CHINO BASIN WATER CONSERVATION DISTRICT

ADDENDUM NO. 2

CIP NO. 2025-01 – NEW AMPHITHEATER ROOF, RECLADDING, AND DRAINAGE IMPROVEMENTS

MAY 6, 2025

PHOTO A - SEATING

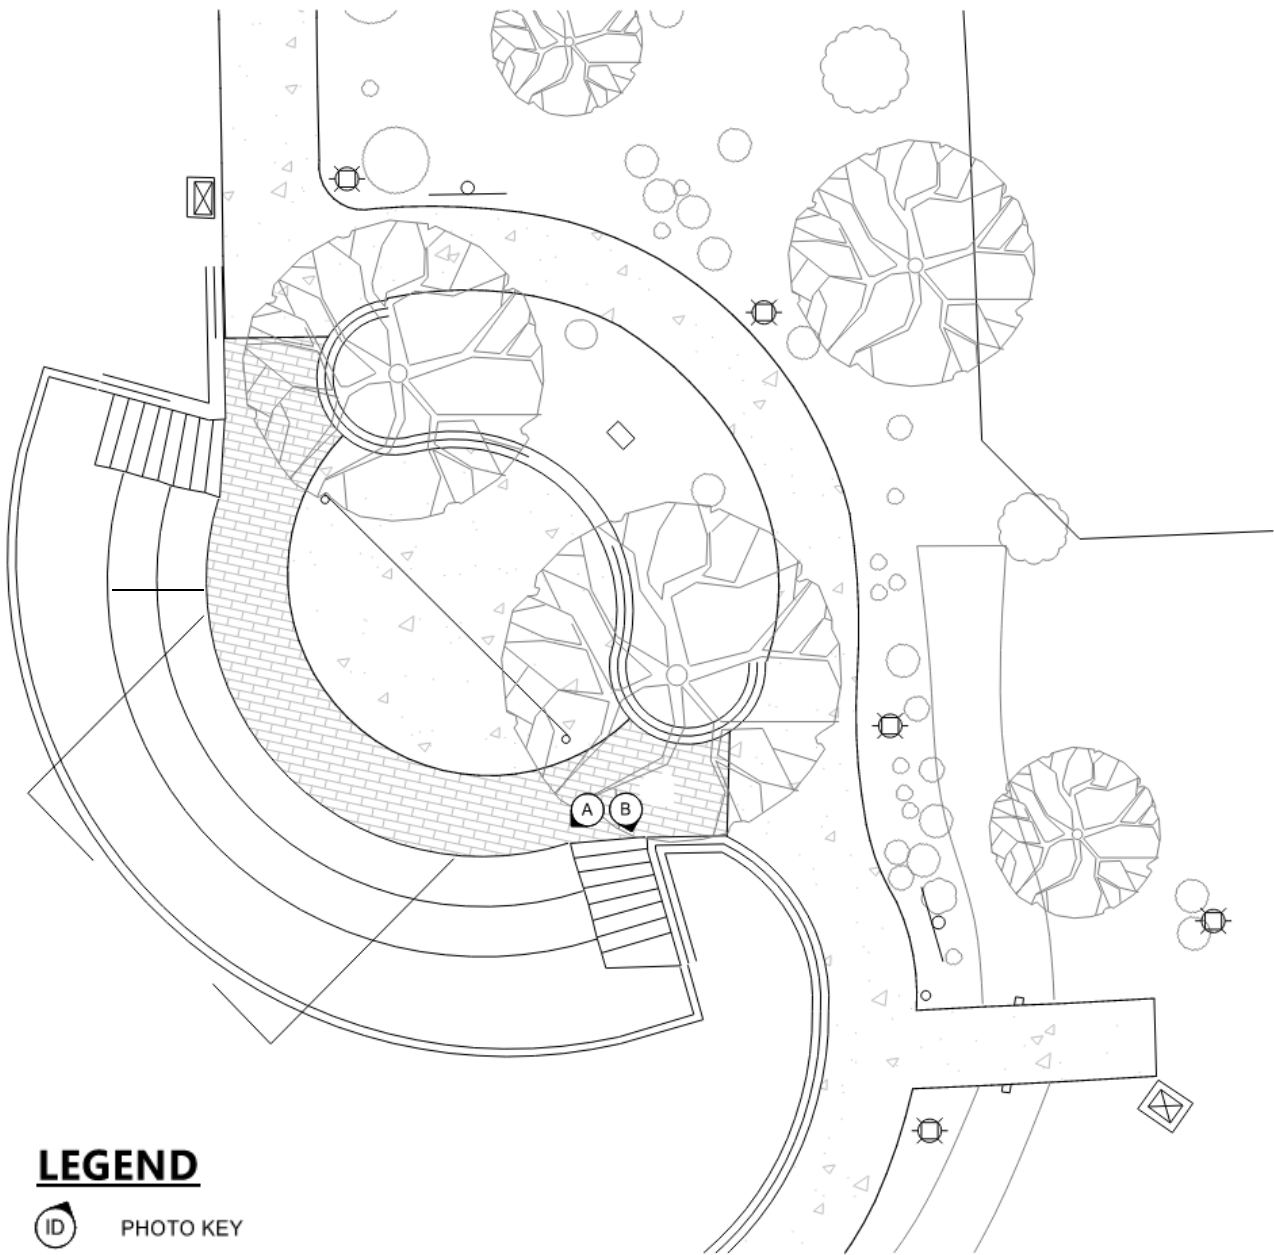
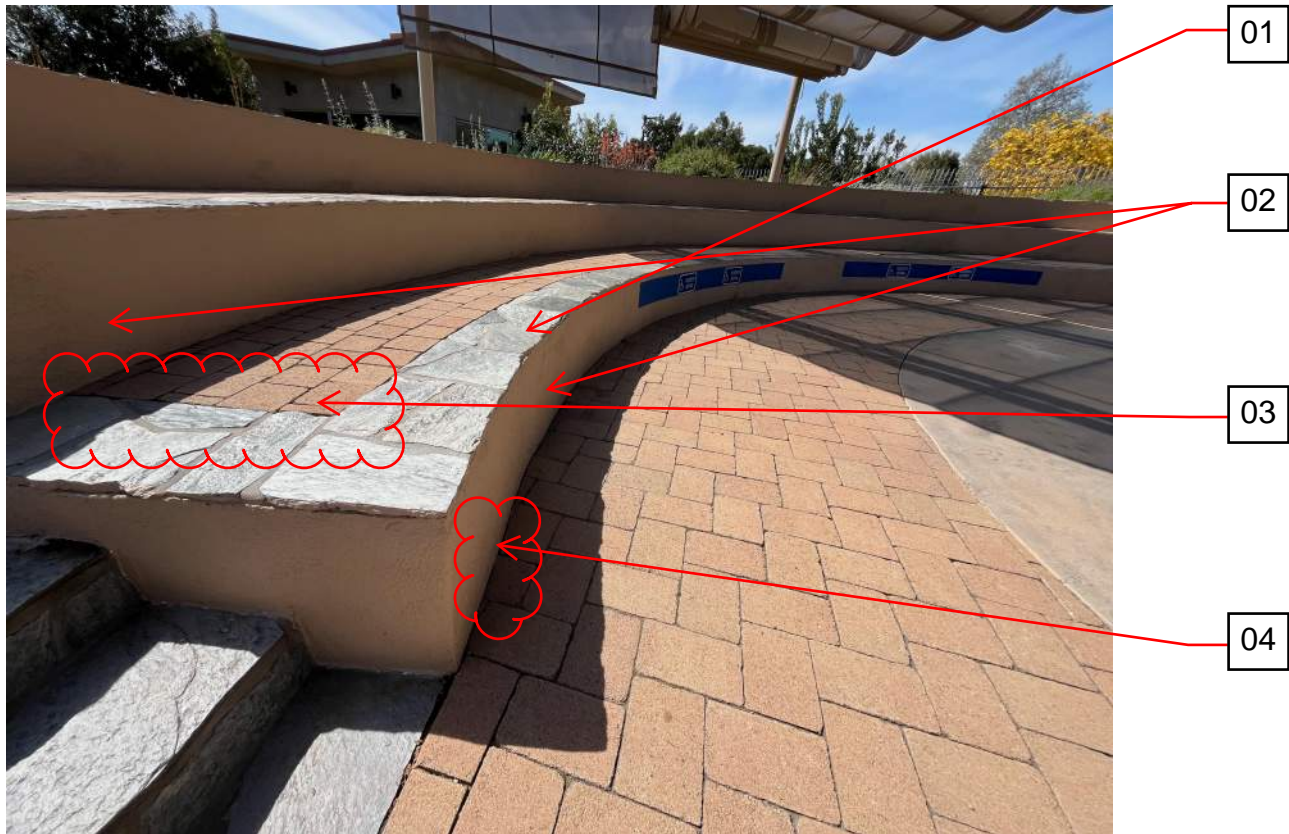
- 01** REPLACE EXISTING RIVERSTONE WITH CONCRETE COPING WITH NOSING PER DETAIL 1/ A-701
- 02** REMOVE EXISTING PLASTER AND STUCCO TO REDO NEW STONE FASCIA AT ALL SEATING LEVELS PER DETAIL 1/ A-701. SEE ADJACENT PICTURE FOR THE EXAMPLE OF STONE FACING AND COPING (DETAIL-9). CLADDING STONES ARE TO BE PROVIDED BY CONTRACTOR, WITH A SAMPLE APPROVED BY THE DISTRICT. STONES TO MATCH "LOCAL RIVER ROCK GRANITE" TYPE, MATCHING THE EXAMPLE IMAGE," OR APPROVED EQUAL.

- 03** EXISTING PAVERS ARE TO REMAIN IN PLACE AND MUST BE PROTECTED DURING CONSTRUCTION TO PREVENT ANY DAMAGE. ANY PAVERS THAT ARE FOUND TO BE DAMAGED OR DISPLACED MUST BE CAREFULLY REMOVED AND REINSTALLED, ENSURING THEY MATCH THE EXISTING LAYOUT AND CURVED PATTERN SEAMLESSLY. THE REINSTALLATION SHOULD ALIGN PRECISELY WITH THE NEW CONCRETE COPING LINE TO MAINTAIN A CONSISTENT FINISH THROUGHOUT THE AREA. TYPICAL FOR ALL THE SEATING THROUGHOUT THE AMPHITHEATER.

- 04** REPAIR/ REPLACE ALL DAMAGED PAVERS ALONG THE NEW STONE FACE. TYPICAL EXISTING PAVERS ARE TO REMAIN IN PLACE AND MUST BE PROTECTED DURING CONSTRUCTION TO PREVENT ANY DAMAGE. ANY PAVERS THAT ARE FOUND TO BE DAMAGED OR DISPLACED MUST BE CAREFULLY REMOVED AND REINSTALLED, ENSURING THEY MATCH THE EXISTING LAYOUT AND CURVED PATTERN SEAMLESSLY. THE REINSTALLATION SHOULD ALIGN PRECISELY WITH THE NEW STONE CLADDING FASCIA TO MAINTAIN A CONSISTENT FINISH THROUGHOUT THE AREA. TYPICAL FOR ALL THE SEATING THROUGHOUT THE AMPHITHEATER.

PHOTO B - STAIRS

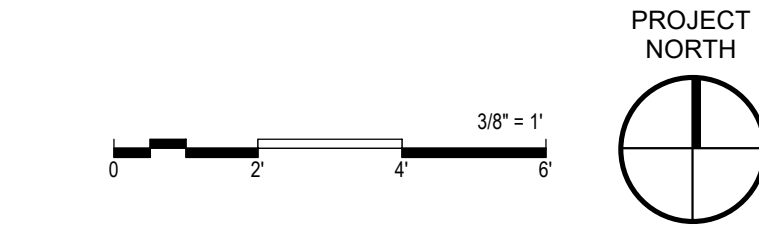
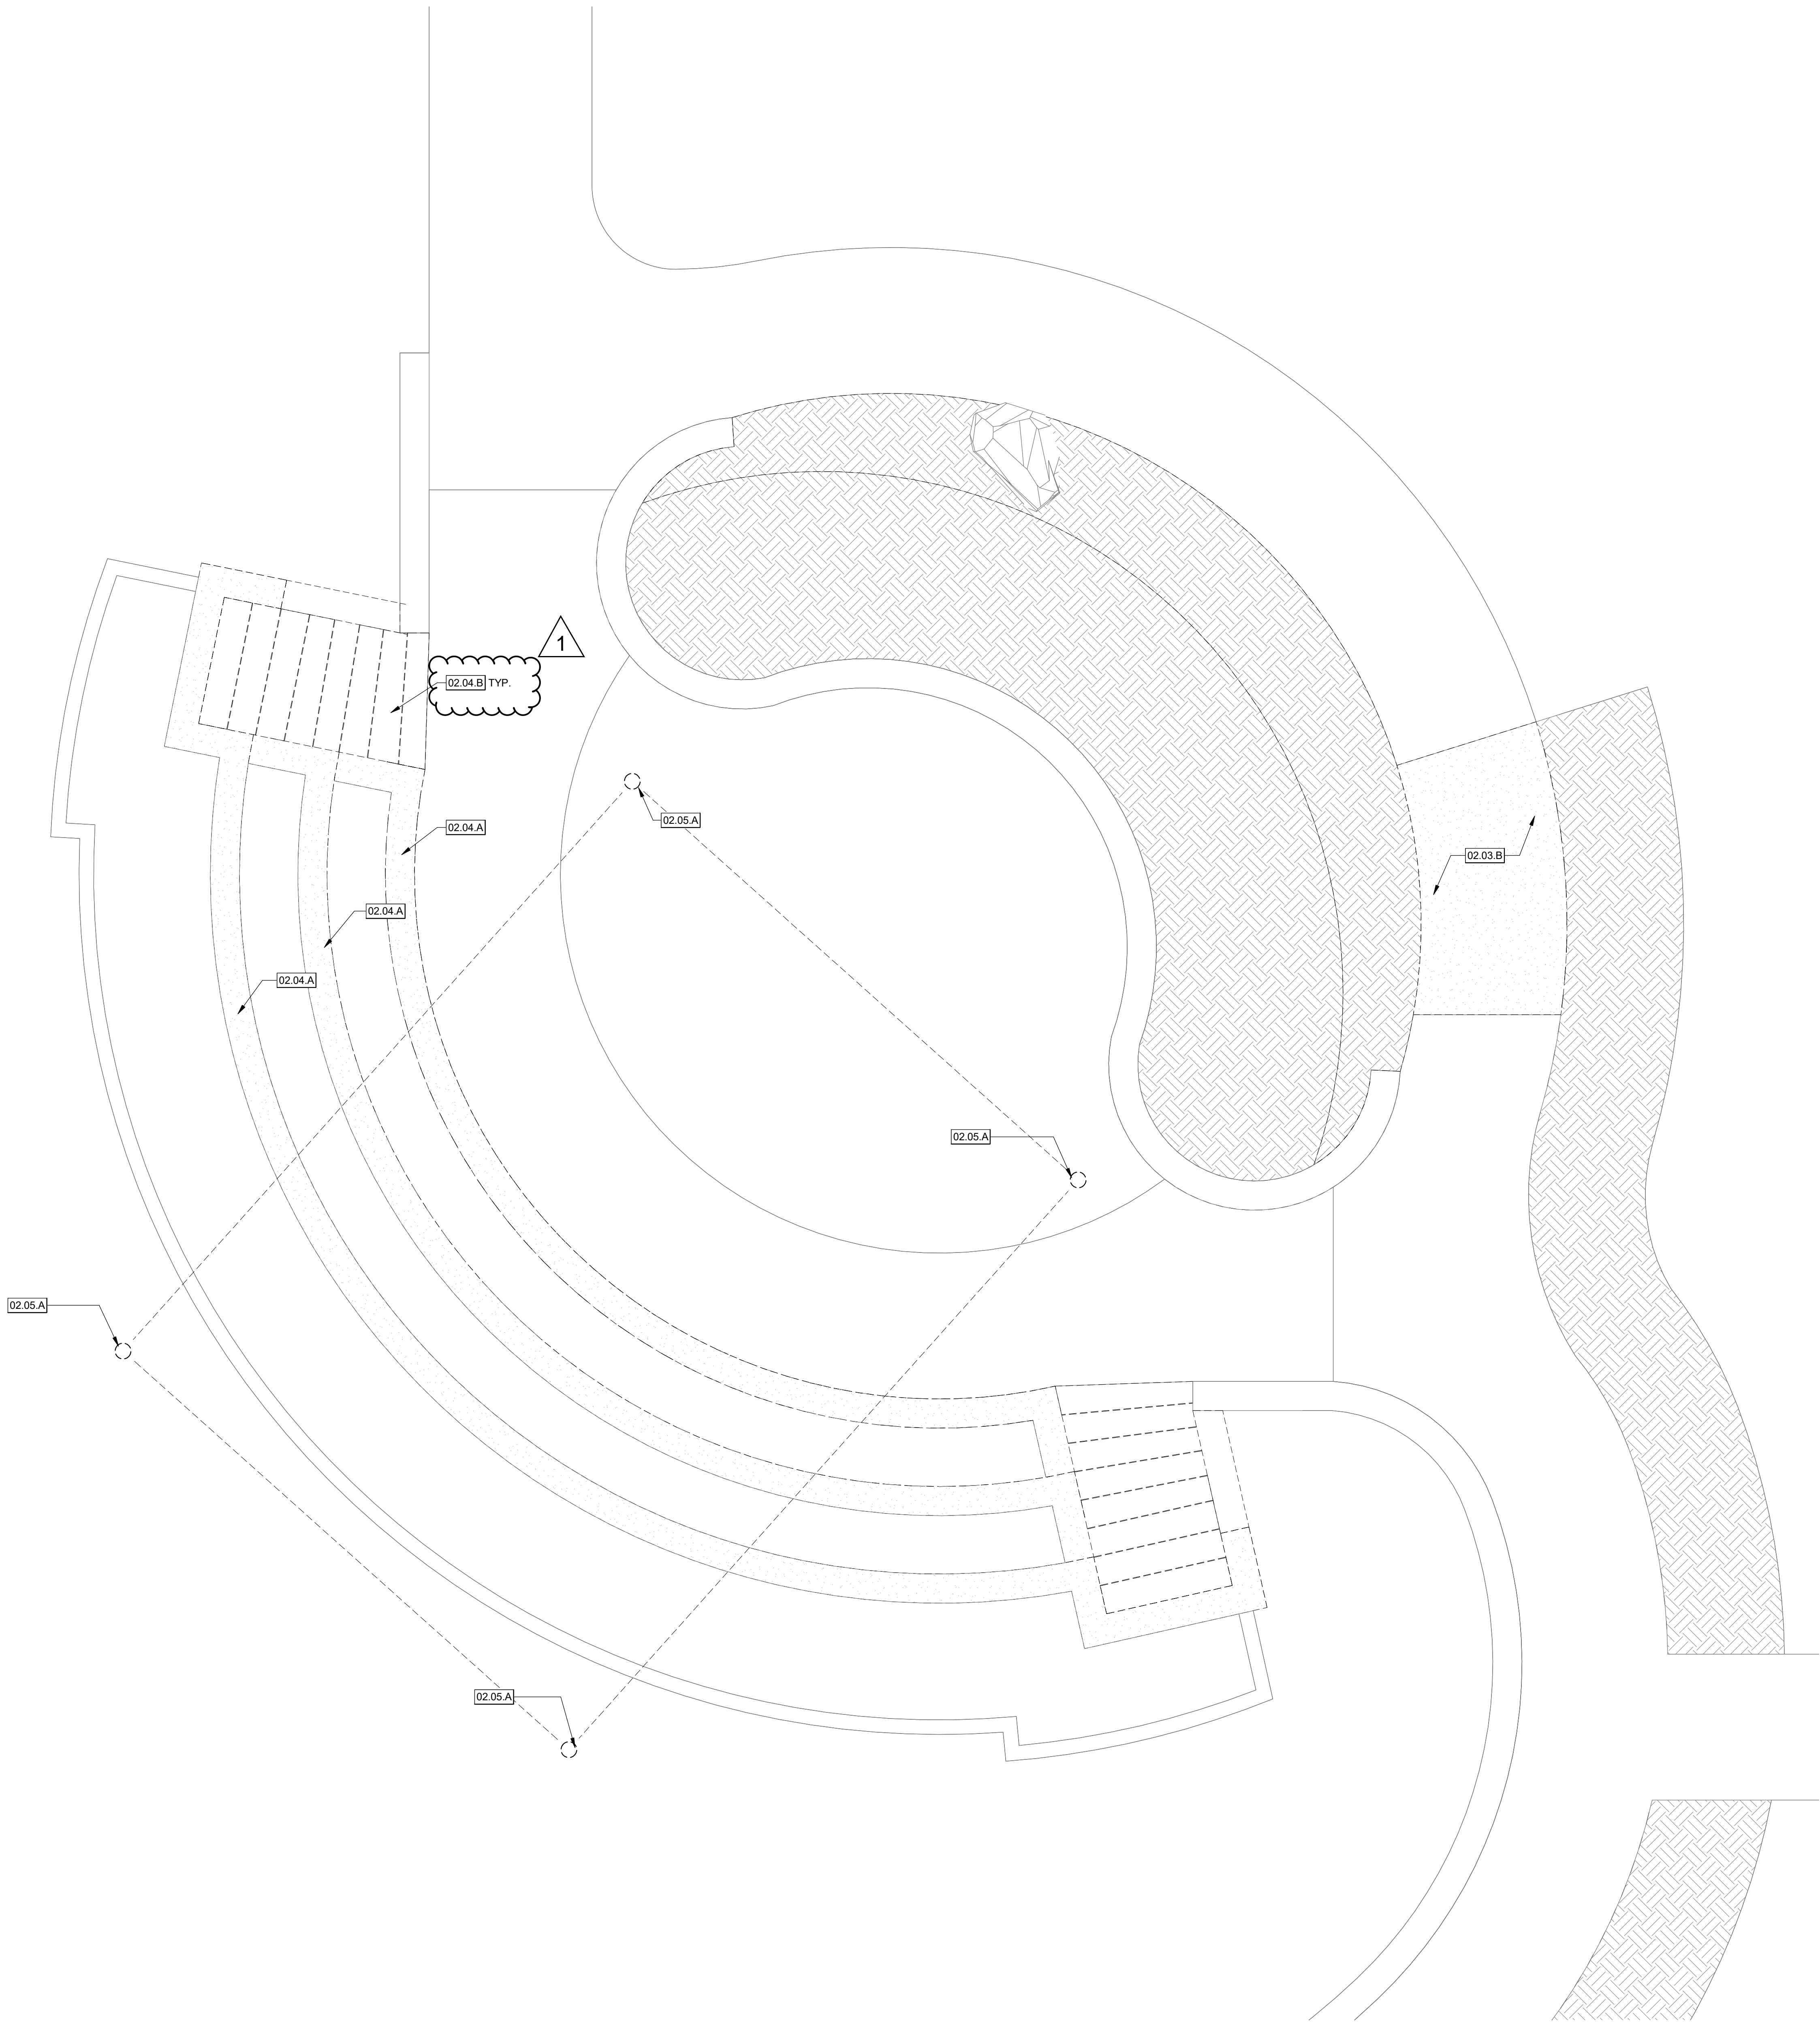
- DEMOLISH EXISTING STAIRS AND CLEAN UP THE SITE TO PROVIDE NEW POURED IN PLACE CONCRETE STAIRS.
- REMOVE EXISTING RIVERSTONE AT BOTH ENDS OF ALL STAIRCASES.
- REMOVE EXISTING RAILING.
- PROVIDE NEW EXTERIOR STAIRS AND RAILINGS PER THE DETAILS SHOWN ON SHEET A-701
